UNITED STATES PATENT AND TRADEMARK OFFICE

APPLICATION NO.	FILING DATE	FIRST NAMED INVENTOR	ATTORNEY DOCKET NO.	CONFIRMATION NO.
10/670,815	09/25/2003	Paul Moulton	A35985 - 070121.0573	7621
21003	7590	08/14/2006	EXAMINER	
BAKER & BOTTS 30 ROCKEFELLER PLAZA 44TH FLOOR NEW YORK, NY 10112				HORTON, YVONNE MICHELE
		ART UNIT		PAPER NUMBER
		3635

Office Action Summary	Application No.	Applicant(s)	
	10/670,815	MOULTON ET AL.	
	Examiner	Art Unit	
	Yvonne M. Horton	3635

DETAILED ACTION

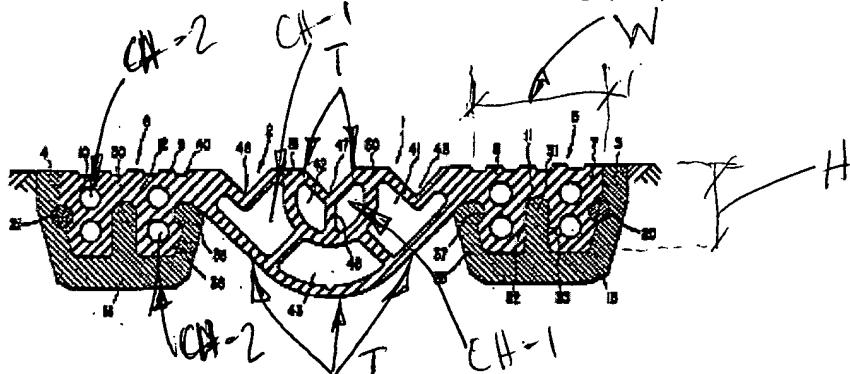
Claim 1 recites that the width of the lateral wings is “substantially” larger than the height of the lateral wings; however, all that is encompassed by “substantially” is not clear. For instance, “substantially” larger with regards to what circumstances (i.e. the distance of the gap between the concrete members, the amount that the compressible members are required to be compressed, etc.). The specification merely states that the

larger block out widths ease placement of the smaller lateral wings during placement of the compression seals. The specification does not detail the specifics of the width and length of the lateral wings or reasons for the length being "substantially" larger than the width.

Claims 1,2,5-8,10,26,30 stand and 38,40 is rejected under 35 U.S.C. 102(b) as being anticipated by US Patent #4,637,085 to HARTKORN. Regarding claims 1,38 and 40, HARTKORN discloses the use of a compression seal for an expansion joint (1) between two adjacent elements (15,16) including a compressible sealing portion (2) having an elastic membranes (T,48) and at least a lateral wing (5,6)

extending therefrom and extruded as one-piece therewith; wherein the lateral wings, have a width (W) and a height (H) such that the width (W) is larger than the height (H) and a thickness (TH) that is larger than the thickness of the elastic membranes (T,48) and are configured to be bonded to a surface of the adjacent elements (15,16).

Regarding the 35 U.S.C.112 rejections above, the applicant has shown no criticality for the length of the lateral wings being 'substantially' larger than the width of the wings.

Clearly, the lateral wings and compressible sealing portion of HARTKORN function equivalently to the instant seal in that the distance between adjacent structures is sealed and maintained there between while being able to accommodate expansion and contraction of the space between the adjacent structures. In reference to claim 2, HARTKORN discloses that his wings (5,) have a thickness of 3.5 cm that converts to 1.37 inches and is at least a half of an inch. Regarding claims 5 and 6, the compressible sealing portion includes a membrane having longitudinal tubes/channels (CH-1) that extends along the length thereof and are inherently known to aid in varying the lateral width of the member. Regarding claims 7 and 8, the lateral wing portion (5,6) includes longitudinal channels (CH-2) and grooves (as at 40). In reference 10, the compressible seal of HARTKORN has the same cross-sectional configuration throughout. Regarding claims 26 and 30, as mentioned earlier, the "tubes/channels" (CH-1) inherently change or deform in order to vary the width of the device.

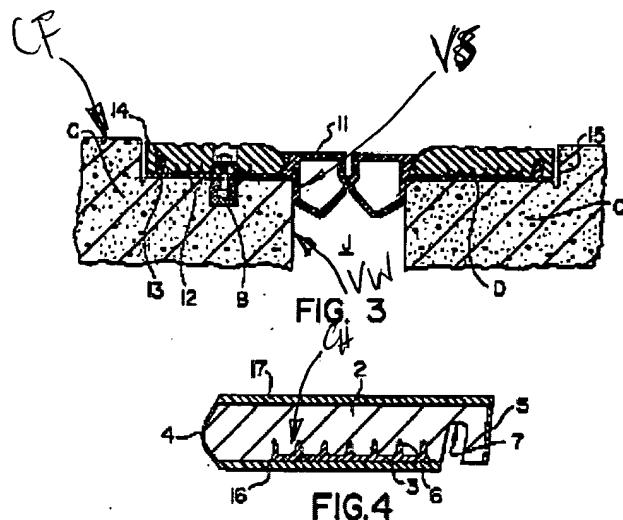
Claims 11-15,19-21,23,25 and 28 stand rejected under 35 U.S.C. 103(a) as being unpatentable over US Patent #5,584,152 BAERVELDT in view of 4,637,085 to HARTKORN. BAERVELDT discloses the use if an expansion system including an expansion joint (J) disposed between adjacent concrete elements (C) of a structure; a one-piece compression seal having a compressible sealing portion (11) having an elastic membranes (T) and at least a lateral wing (12) extending laterally from a top portion (TP) of the compressible seal (11); and a block-out region (letter (e) column 4) such that the block-out region is adapted to receive the lateral wing (12) and is bonded thereto. BAERVELDT discloses the basic claimed expansion joint system except for the lateral wings having a thickness larger than the thickness of the elastic membranes. HARTKORN teaches that it is known in the art to form lateral wings (5,6) of a compression seal (1) such that he thickness of the lateral wings (5,6) is larger than the thickness of the elastic membranes (T,48). Hence, it would have been obvious to one having ordinary skill in the art at the time the invention was made to provide the compression seal of BAERVELDT with lateral wings having a larger thickness than the elastic membranes, as taught by HARTKORN in order to enhance the rigidity of the joint

seal. Regarding claim 12, BAERVELDT discloses the use of a block-out region (as at 15) that has a thickness slightly greater than the lateral wing thickness (12). In reference to claim 13, HARTKORN teaches that his wings (5,) have a thickness of 3.5 cm that converts to 1.37 inches and is at least a half of an inch. In reference to claims 14 and 15, BAERVELDT discloses that his lateral wings (12) are bonded by adhesives and is bolted as at (B) to the block-out regions (column 4, letter (h)).

Regarding claim 19, the compressible sealing portion includes longitudinal tubes (CH-1) that extends along the length thereof. In reference to claim 20, the compressible sealing portion includes a membrane having longitudinal tubes/cavities (CH-1) that extends along the length thereof and are inherently known to aid in varying the lateral width of the member. Regarding claims 21, the lateral wing portion (5,6) includes longitudinal channels (CH-2). In reference 23, the compressible seal of BAERVELDT has the same cross-sectional configuration throughout. In reference to claim 25, the concrete elements (C) include a floor (CF), and a vertical wall (VW) wherein the compressible sealing portion (11) includes vertical side walls (VS) that are bonded to the vertical walls (VW) of the concrete floor (CF). Regarding claim 28, the "tubes/channels" (CH-1) inherently change or deform in order to vary the width of the device.
